RE: **Kidz Academy**
McMahon and Fineland NW
Grading Plan and Drainage Report
Engineer's Stamp Date 2/12/18 (File: A11D016)

Based on the information provided in your submittal received 2/12/18, the Grading Plan and Drainage Report cannot be approved until the following are corrected:

RE: **Kidz Academy**
McMahon and Fineland NW
Grading Plan and Drainage Report
Engineer's Stamp Date 1/18/18 (File: A11D016)

Based on the information provided in your submittal received 1/18/18, the Grading Plan and Drainage Report cannot be approved until the following are corrected:

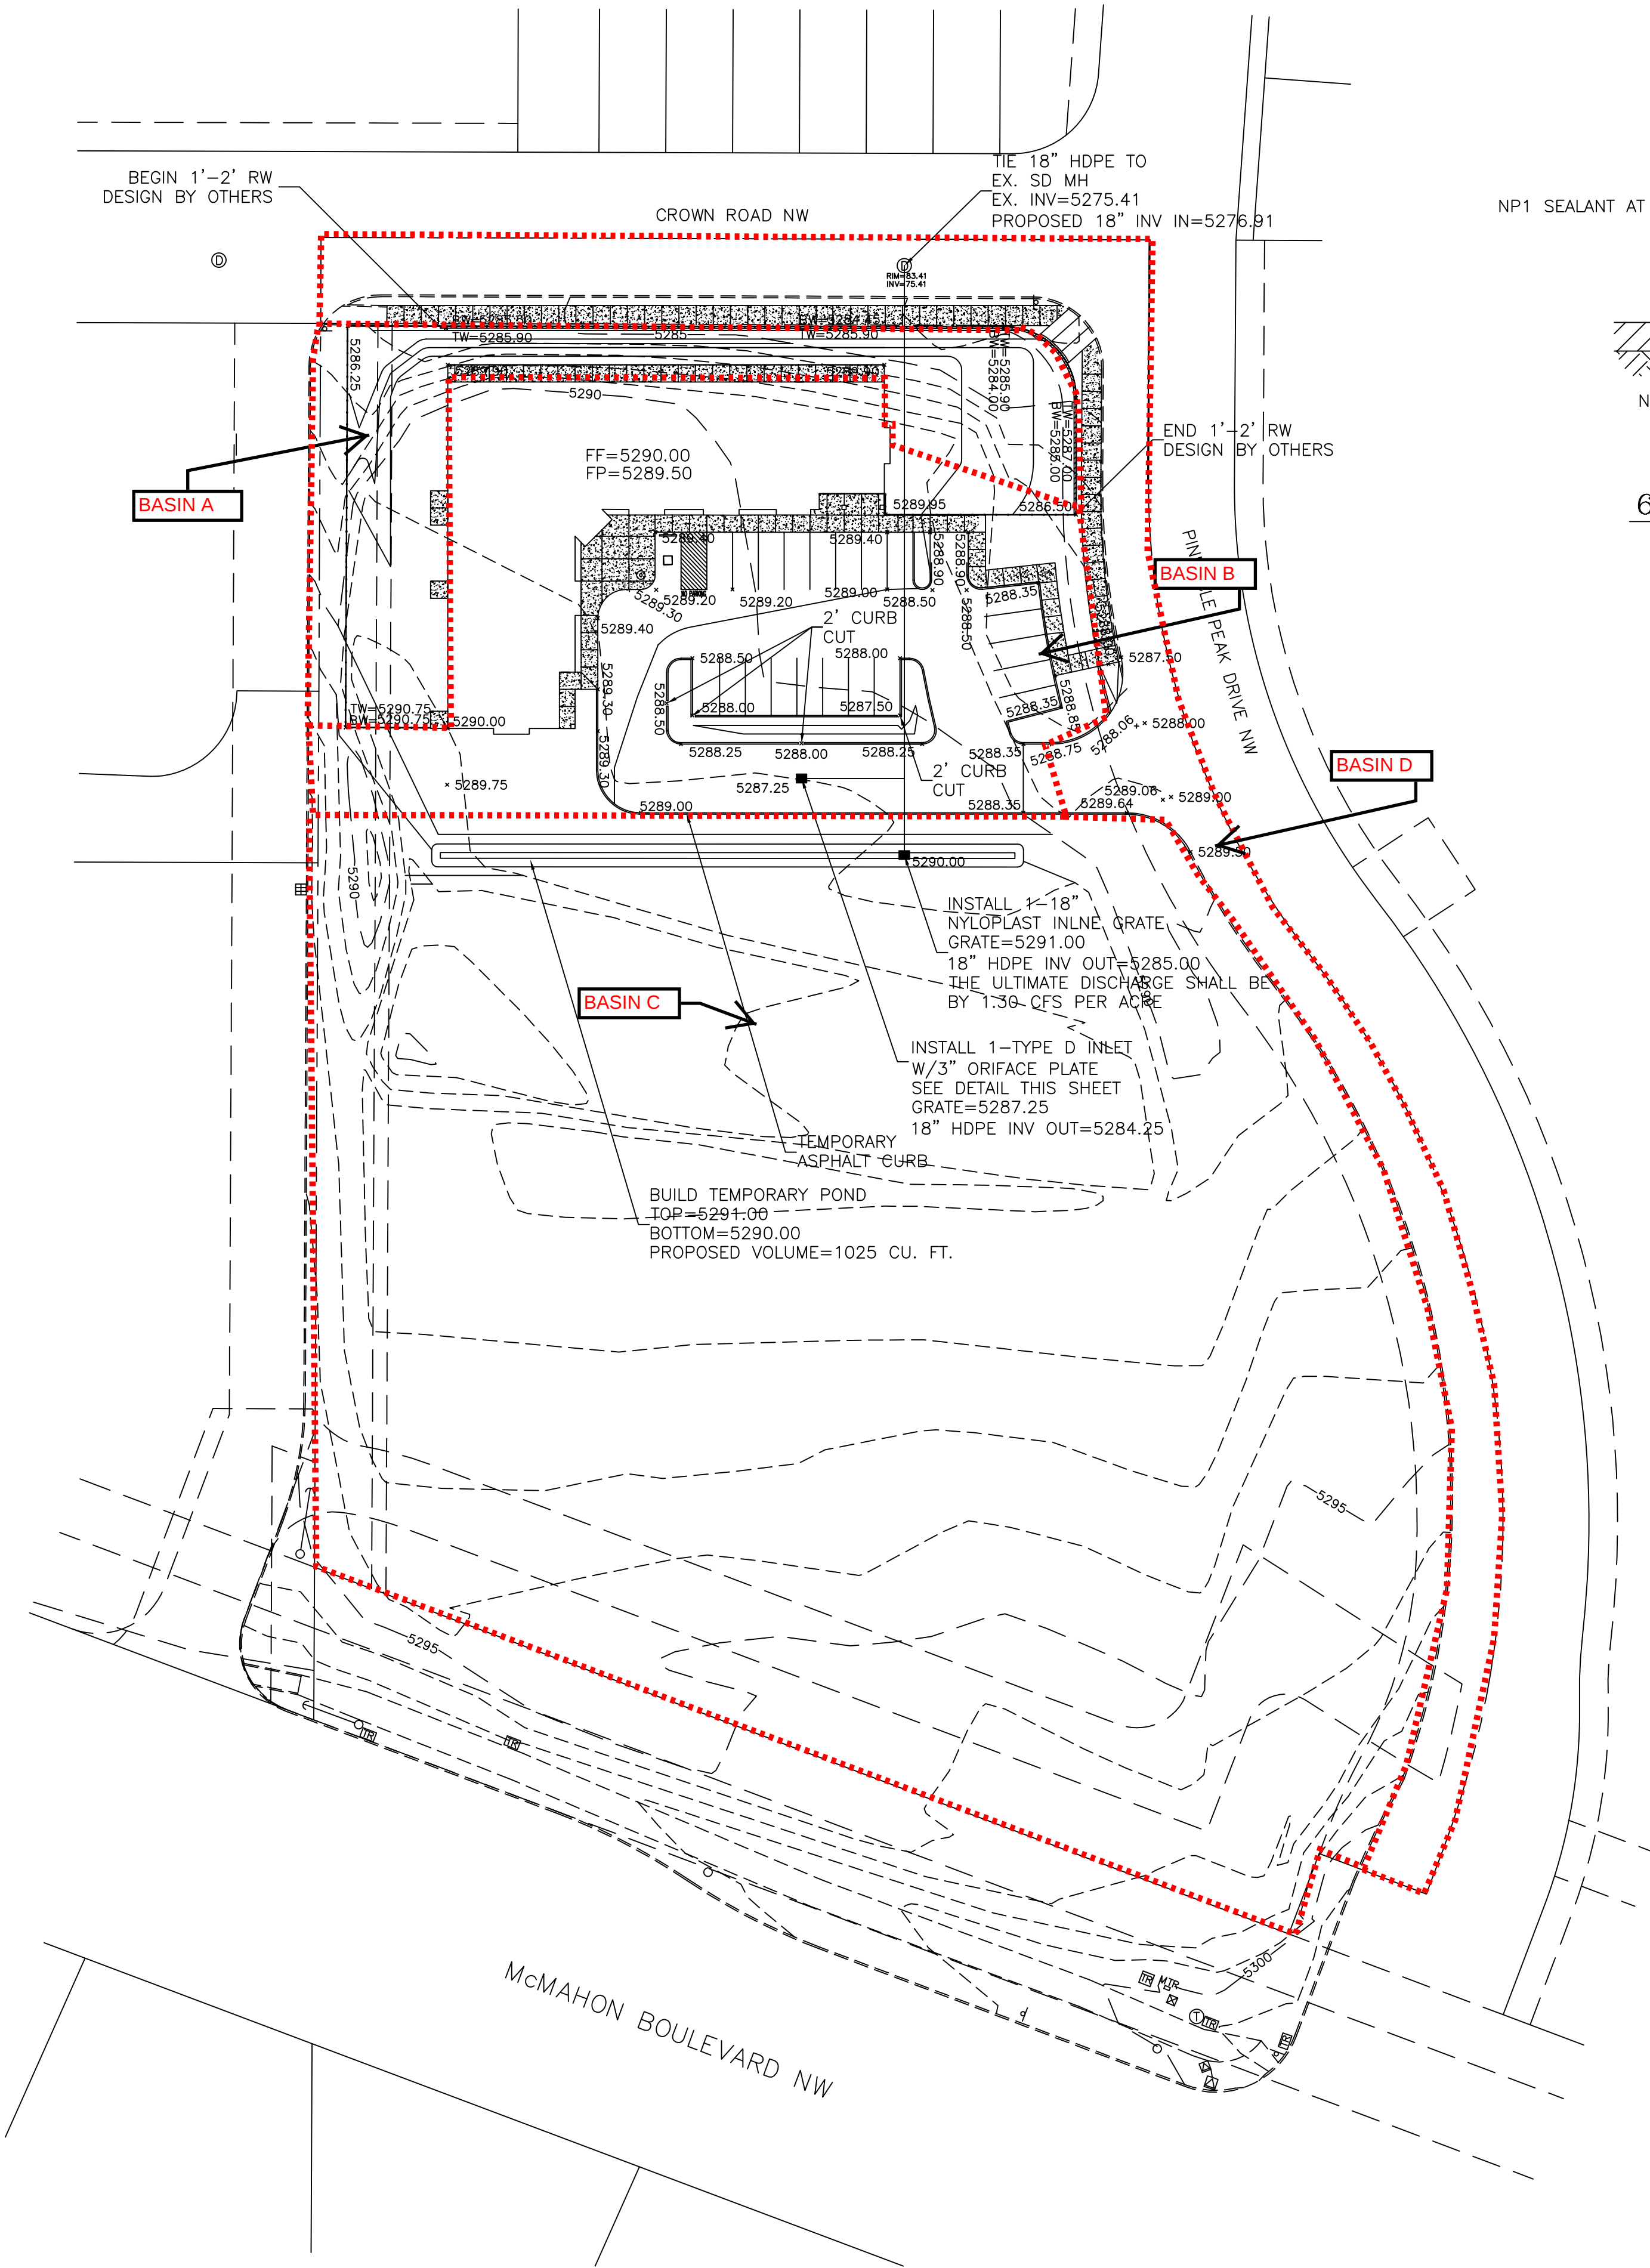
1. The current approved grading plan (Goodwin-2018) and the new plat allow blanket cross lot drainage to a new pond (not constructed) with zero discharge from this larger site. This plan will need to restrict upstream discharge from Lot A1B with a new pond on lot A1B restricting discharge to at least 1.3cfs/ac. A Drainage Covenant (no public easement) will be required for this pond and be granted by the owner of Lot A1B.
WE HAVE REVISED TO POND LOT A1B IN THE INTERIM

4. The approved Drainage Master Plan that allows 1.3 cfs/acre also includes the half streets of Crown Road and Fineland Road. Please add the free discharge associated with these areas to your runoff analysis
WE HAVE UPDATED THE CALCULATIONS AND ORIFICE

5. Provide RCP CL III pipe in the Crown Road ROW. There should also be an existing 18" RCP pipe with drop inlet coming from this manhole and onto the property; why not make use of that? This drainage connection will also need to be listed on the Infrastructure List. **THE INLET HAS NOT BEEN CONSTRUCTED.**
WE HAVE ADDED INLET AND PIPE

6. Show the new lot lines on the grading plan, including the ROW takes for Crown and Fineland.
WE HAVE ADDED

7. Please specify a square opening on the orifice plate.
A ROUND ORIFICE IS EASIER TO CONSTRUCT, WE REQUEST IT TO REMAIN
8. Please label this Grading Plan as "conceptual, not for construction" or similar.
WE ARE ASKING FOR GRADING PERMIT UNDER THIS PLAN

9. How is the roof drainage routing through a first flush/detention pond? The drains appear to be plumbed directly to the private storm drain. More detail is need on the ponds and storm drains to demonstrate that they will intercept flows and adequately restrict discharge from the site. **OUTFALL CONTROLLED BY ORIFICE PLATE. ROOF DRAINS CONNECT IN INLET UPSTREAM OF THE RESTRICTION**

10. Quantify the volume of first flush bypass and state on plans. It appears there may be some bypass from the drive entrance, but it is unclear with the new ROW line.

11. This site has been graded several times and no land treatment A remains, Please update the proposed Hydrology to reflect. **WE HAVE UPDATED**
12. There are two Basin C's on the subbasin map and no Basin A; Please correct.

ENGINEER'S SEAL  2/12/18 DAVID SOULE P.E. #14522	KIDZ ACADEMY GRADING AND DRAINAGE PLAN  1606 CENTRAL AVENUE SE SUITE 201 ALBUQUERQUE, NM 87106 (505) 872-0999	DRAWN BY WCWJ DATE 2-12-18 21801-LAYOUT-9-25-17 SHEET # JOB # 21801
---	--	---

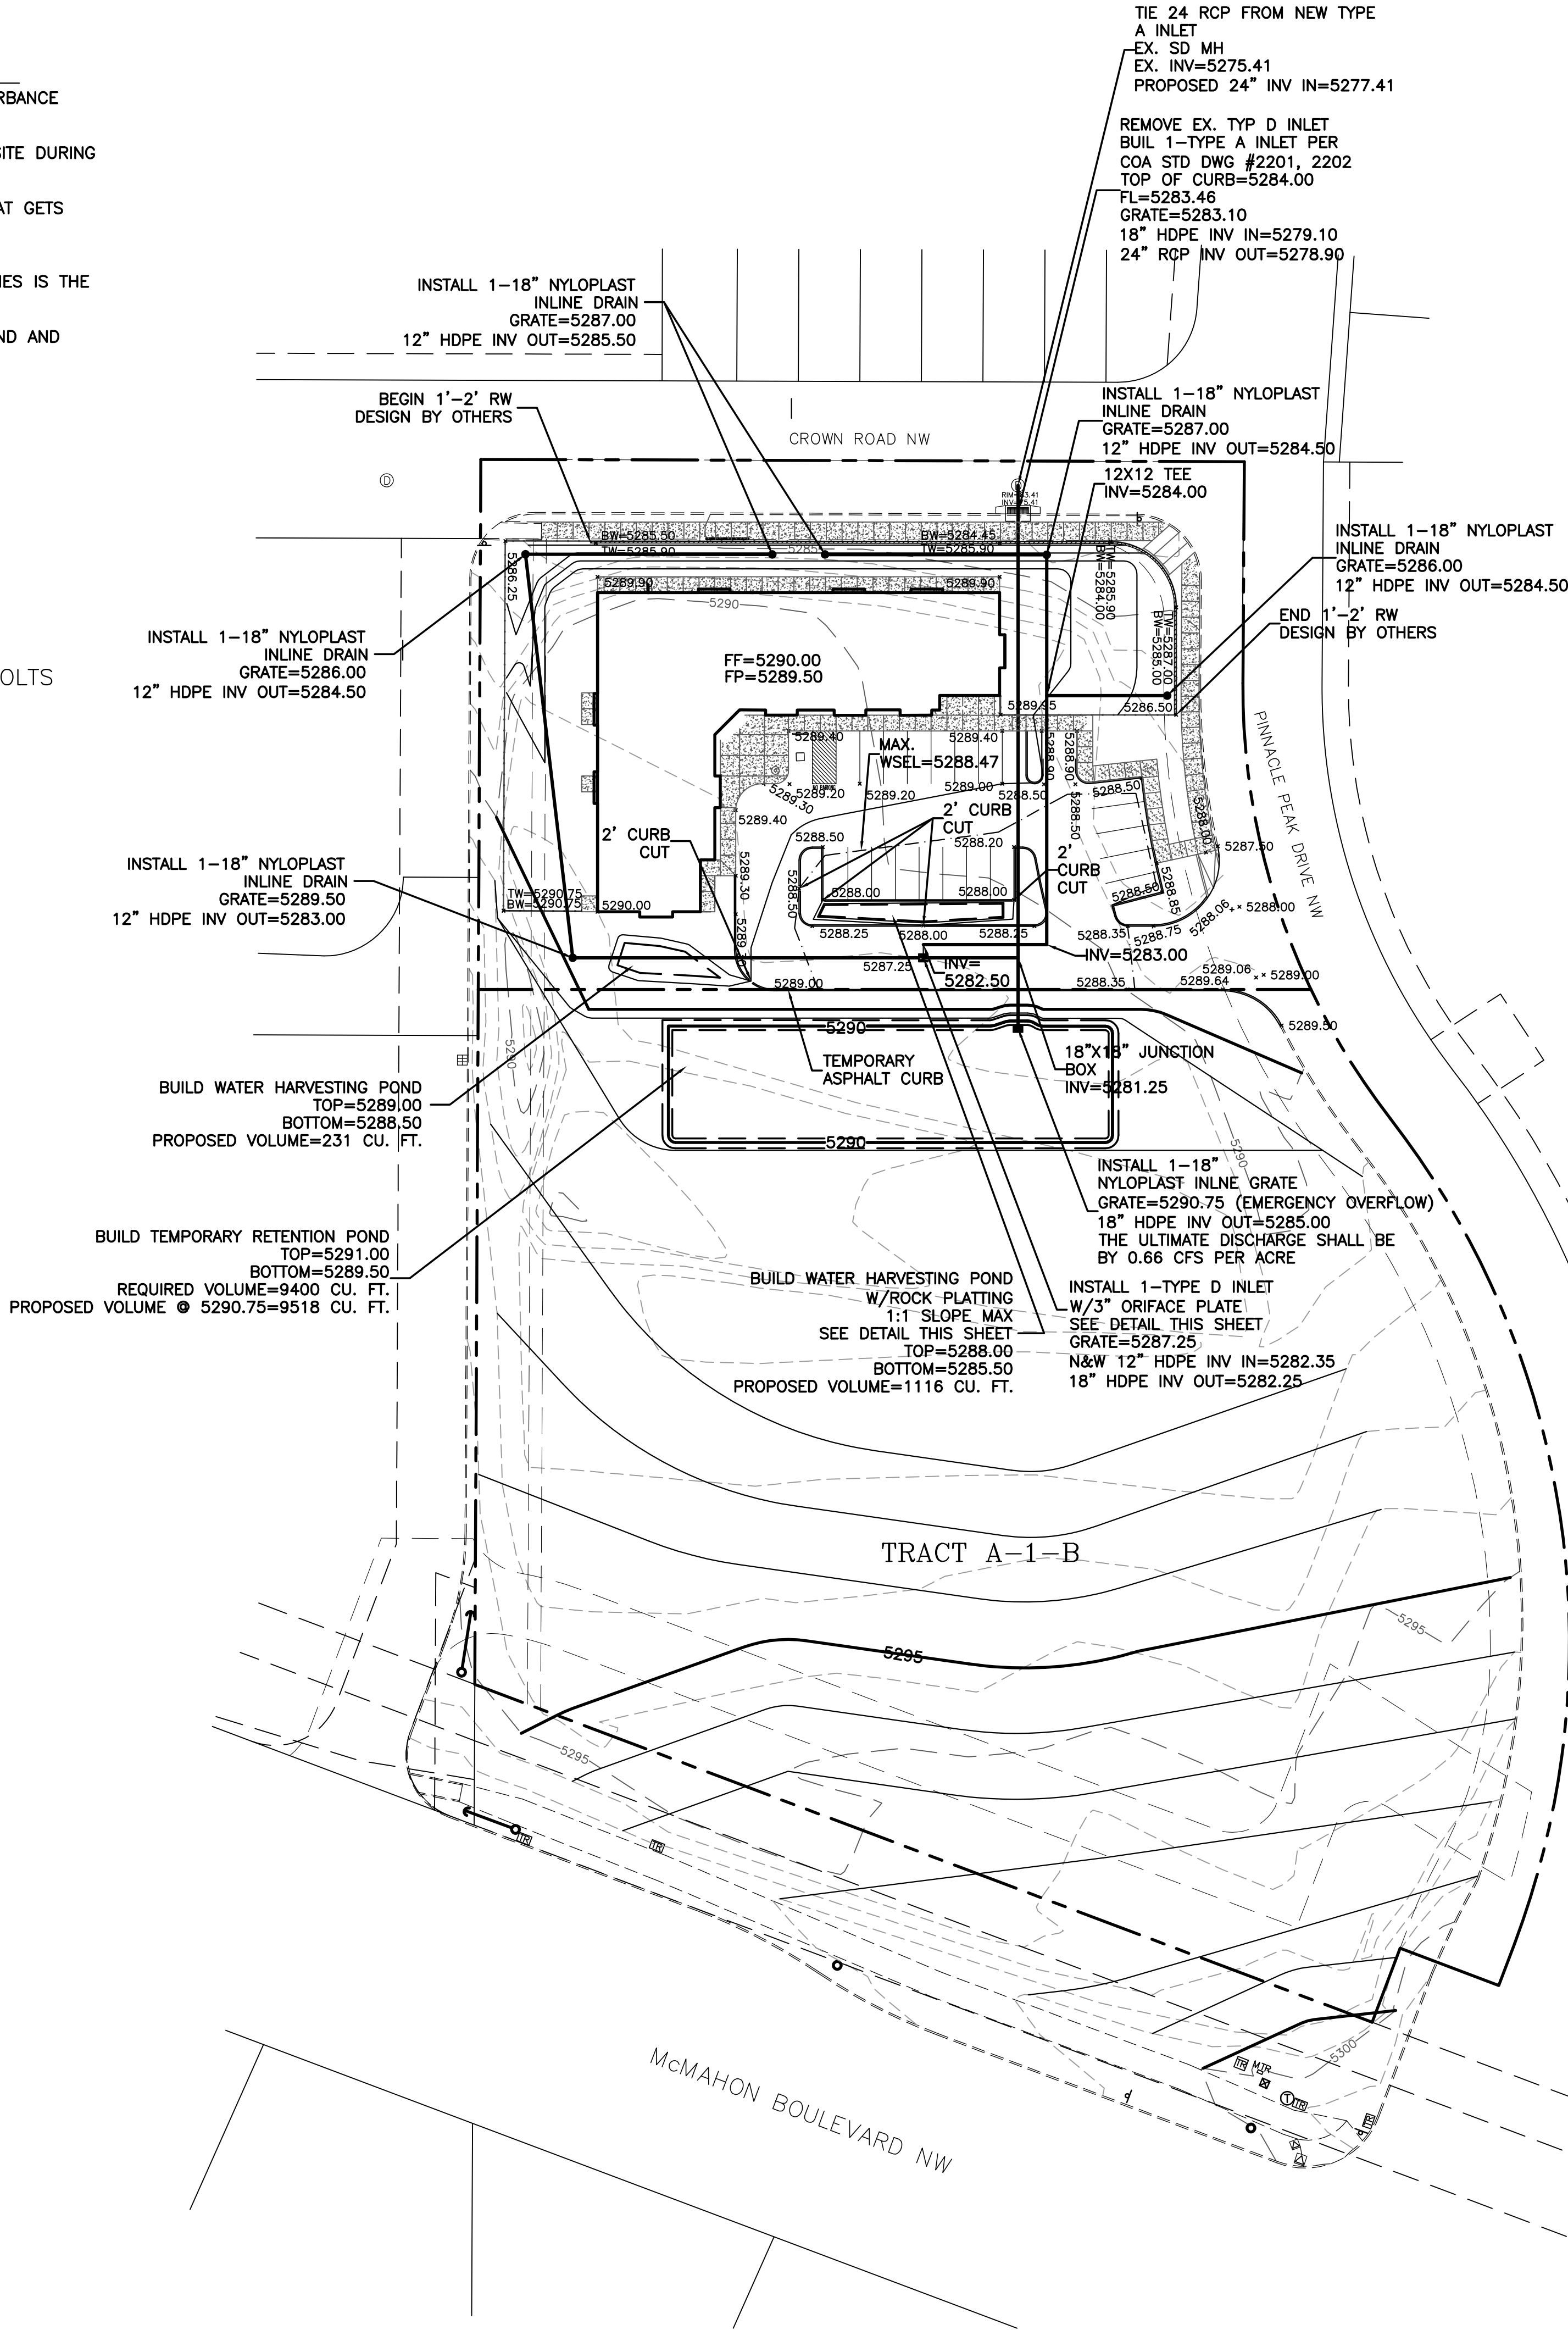
3. If no longer under common ownership, provide written permission from the adjoining landowner (Lot A1B) for grading and work on their property.
4. The AHYMO model shows the pond as having outflows beginning at elevation 85.52', but on the plan, the inlet grate elevation is at 87.25'. Please clarify the routing. Is this outflow from Basin A bypassing the pond and going right to the orifice plate inlet?

5. What is the function of the storm drain w/ inline drains around the building? Previously these were used for routing the roof drains to the orifice plat/inlet near the pond, but now they seem to be just for area drains to capture runoff from Basin A. If so, they do not appear to be placed where they will intercept all flows from Basin A.

6. The small amount of impervious area in Basin A does not appear to be routing through any first flush pond. It appears to either free discharge onto Crown Rd or get routed through the orifice plate/inlet, but not get retained anywhere. If true payment, of Fee-in-Lieu will be required for this impervious area.
